City of Buckley

Re: Arcadia Arts, SPR 2014-02, design review for Phase I; File #:DR-3102

Proposed site plan, Phase I

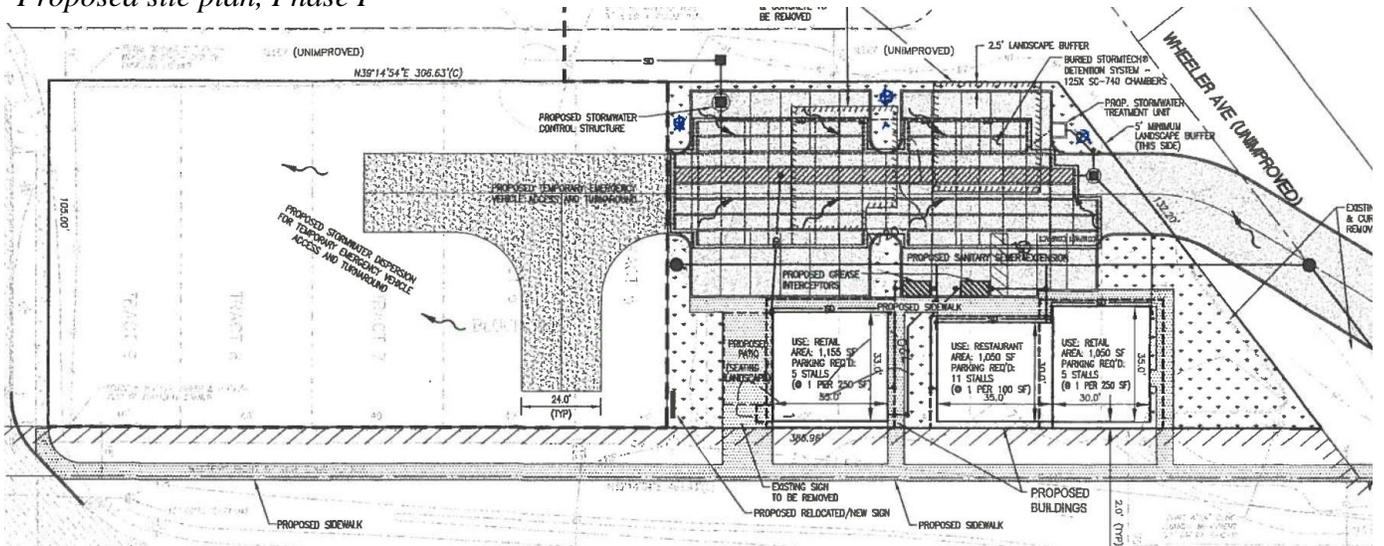
In a February 17, 2016 e-mail, Fire Chief Alan Predmore said the proposed abbreviated site plan will be acceptable as long as no parking signs are posted and the area doesn't become obstructed with overflow parking.

Building 1.

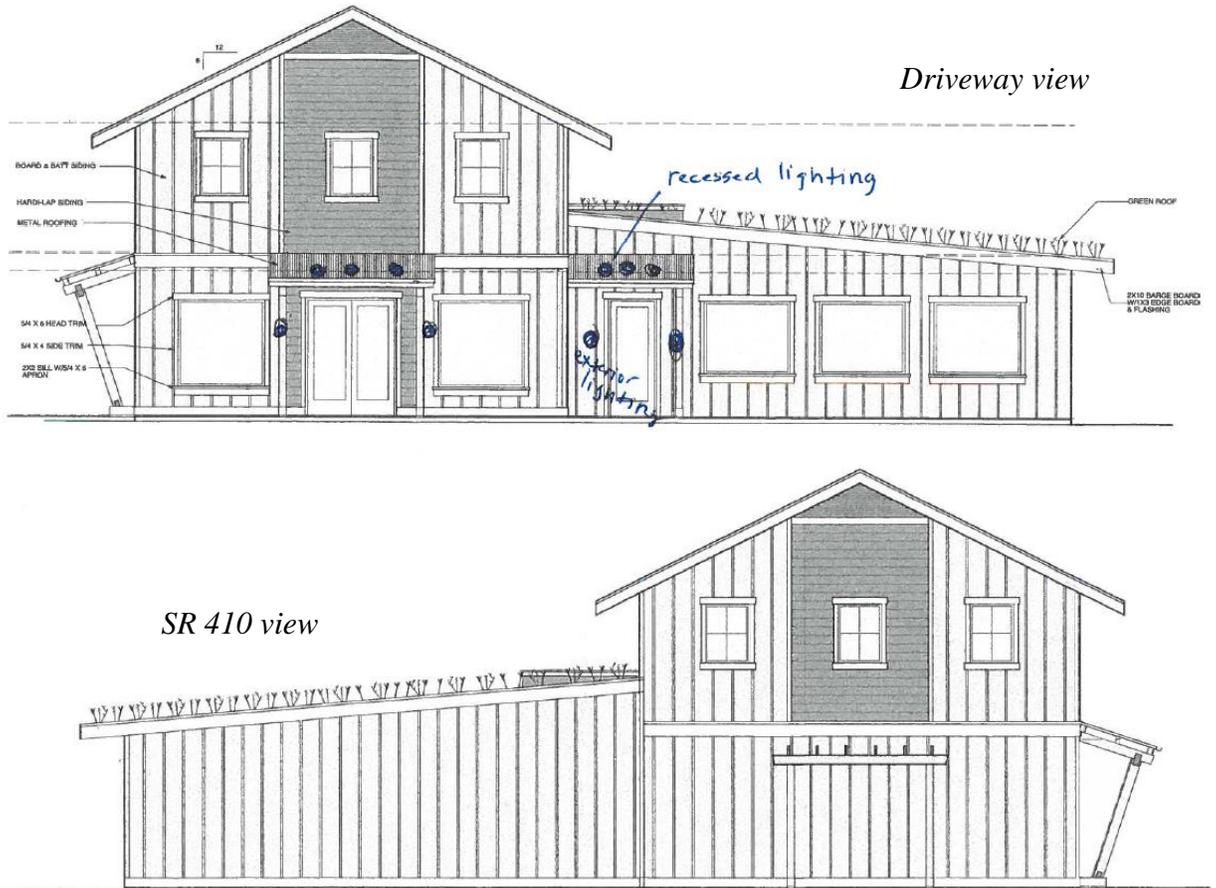
Building 1 is about 35 feet deep and contain two separate businesses, The New Leaf Café at about 1,050 sf and a retail/upstairs office area at about 2,100 sf. The New Leaf is planned to be about 35 feet wide and the retail area with office above is planned to be about 30 feet wide. A green roof is planned to be above the café.

Building 2.

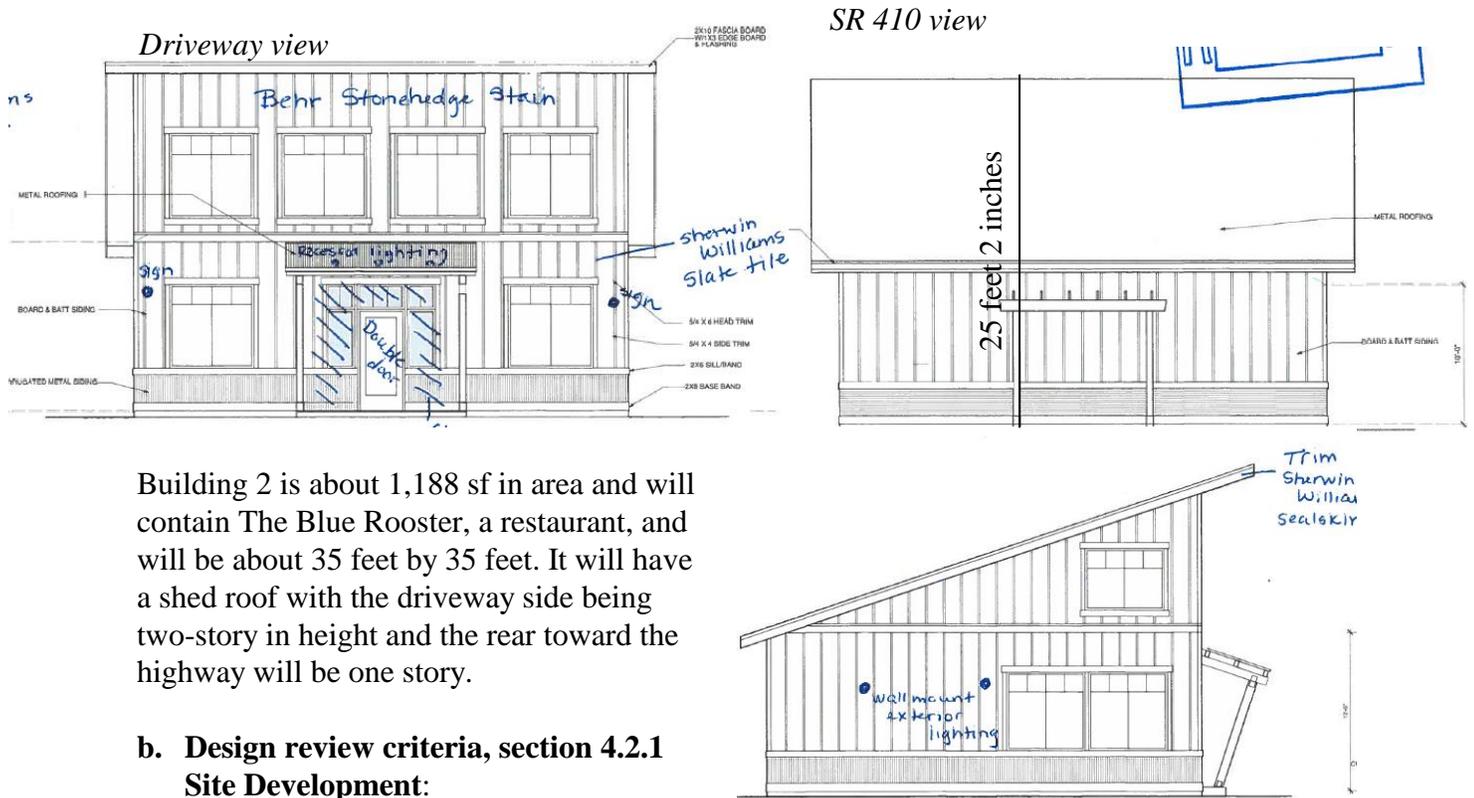
Building 2 is about 1,188 sf in area and will contain The Blue Rooster, a restaurant, and will be about 35 feet by 35 feet. It will have a shed roof with the driveway side being two-story in height and the rear toward the highway will be one story.

Findings: A lower pitch on one of the buildings is requested to ensure the success of a green roof. Building 1 is two stories, Building 2 is one story. The Blue Rooster roof is 4:12; a 6:12 slope may increase the apparent height of the building. The two-story building with gables is 6:12. The DRC approves the roof forms as proposed.
